# Access Compliance Report

## Public Rights-of-Way

### (Curb Ramps)

Intersection ID: 11545	Main Street: CARDIFF_AV	Cross Street: HILLIARD_DR	Location: NE
ADA ID: B2D4C0A4E466	Ramp Type: Perp	Initial Pass/Fail: Fail	Overall Compliance: No
Codes/Mitigation Info/Possible Solution			Severity Score: 10
			Field Measurements/Component Compliance

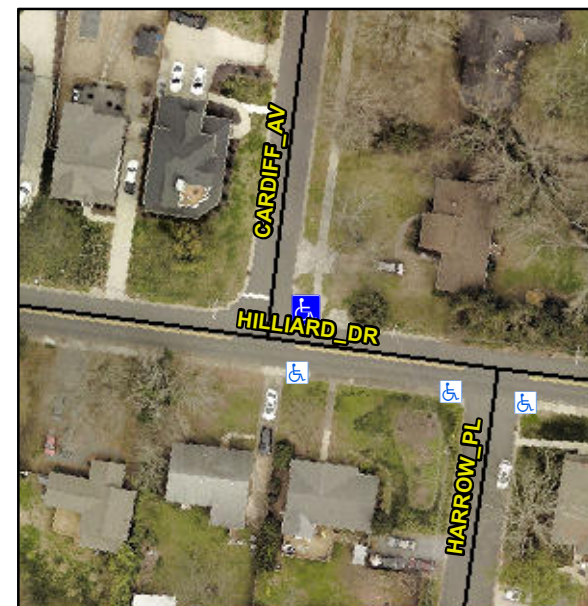
**Not Found, R304.5.1, R304.5.3**

Compliance	Description	Data	Compliance	Description	Data
N/A	Ramp Length (in)	103.0	Yes	Ramp Slope (%)	8.3
No	Ramp Width (in)	44.0	No	Ramp XSlope (%)	4.9
N/A	Flare Type LT	N/A	N/A	Flare Type RT	N/A
N/A	Flare Slope LT (%)	N/A	N/A	Flare Slope RT (%)	N/A
N/A	Flare Traversable LT?	N/A	N/A	Flare Traversable RT?	N/A
N/A	Landing Length (in)	N/A	N/A	DWS Provided?	N/A
N/A	Landing Width (in)	N/A	N/A	DWS Contrast?	N/A
N/A	Landing Slope (%)	N/A	N/A	DWS Length (in)	N/A
N/A	Landing X Slope (%)	N/A	N/A	DWS Full Width?	N/A
N/A	Landing Curb? (Y/N)	N/A	N/A	DWS Offset (in)	N/A
N/A	Shared Landing?	N/A			
N/A	Gutter Ponding?	N/A	N/A	Gutter Slope (%)	N/A
N/A	Gutter Lip Ht (in)	N/A	N/A	Gutter X Slope (%)	N/A
N/A	Painted X Walk1?	No	N/A	Painted X Walk2?	N/A
	X Walk 1 Direction	To SW		X Walk 2 Direction	N/A
N/A	X Walk 1 Width (in)	N/A	N/A	X Walk 2 Width (in)	N/A
	X Walk 1 Slope (%)	0.9		X Walk 2 Slope (%)	N/A
	X Walk 1 X Slope (%)	1.2		X Walk 2 X Slope (%)	N/A

**Remove & Replace Entire Ramp.**
